7th Edition (2020)

**ROOFING TAC
WITHOUT COMMENTS**

TAC: Roofing

FIGURE 1

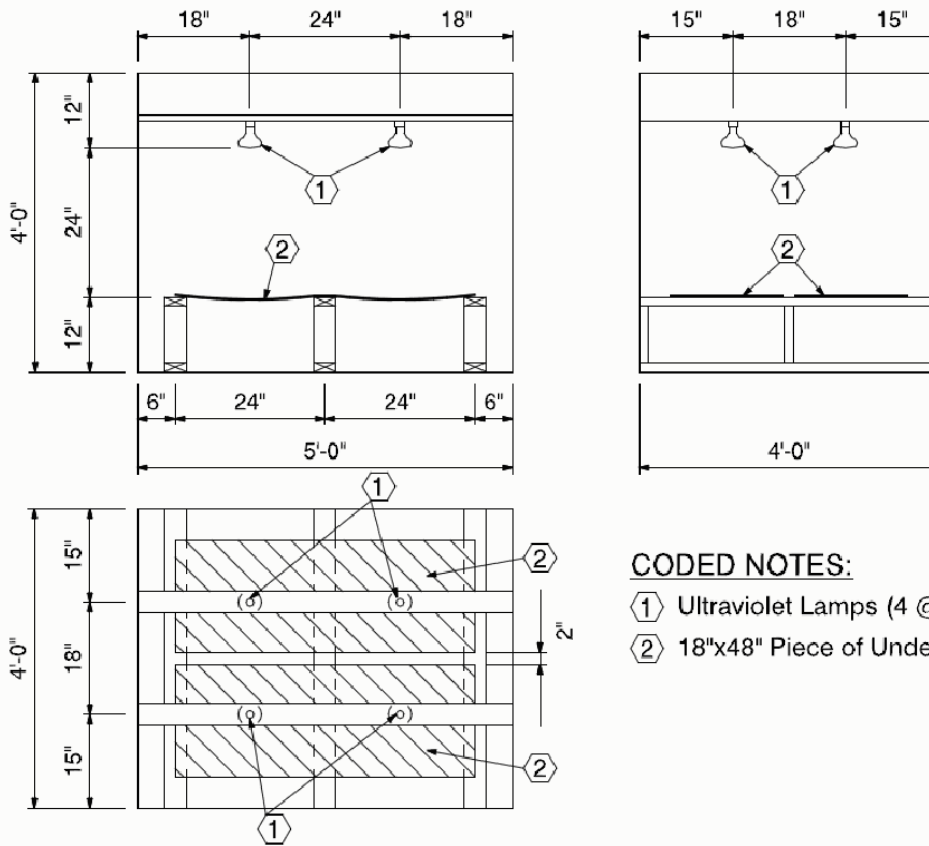
12.1.2.2 Ultraviolet light shall be produced by four ~~300 275 W watt~~ UV lamps in an enclosure in accordance with Figure 1. Recommended lamps are: Ultra-Vitalux, ~~300 275 W~~, 220-230 V, #E27, ~~or Osram 300 275 W lamps~~, or; equivalent bulbs providing UV characteristics of 5.0 W/m²/nm irradiance at a wavelength of 315 to 400 nm at one meter.
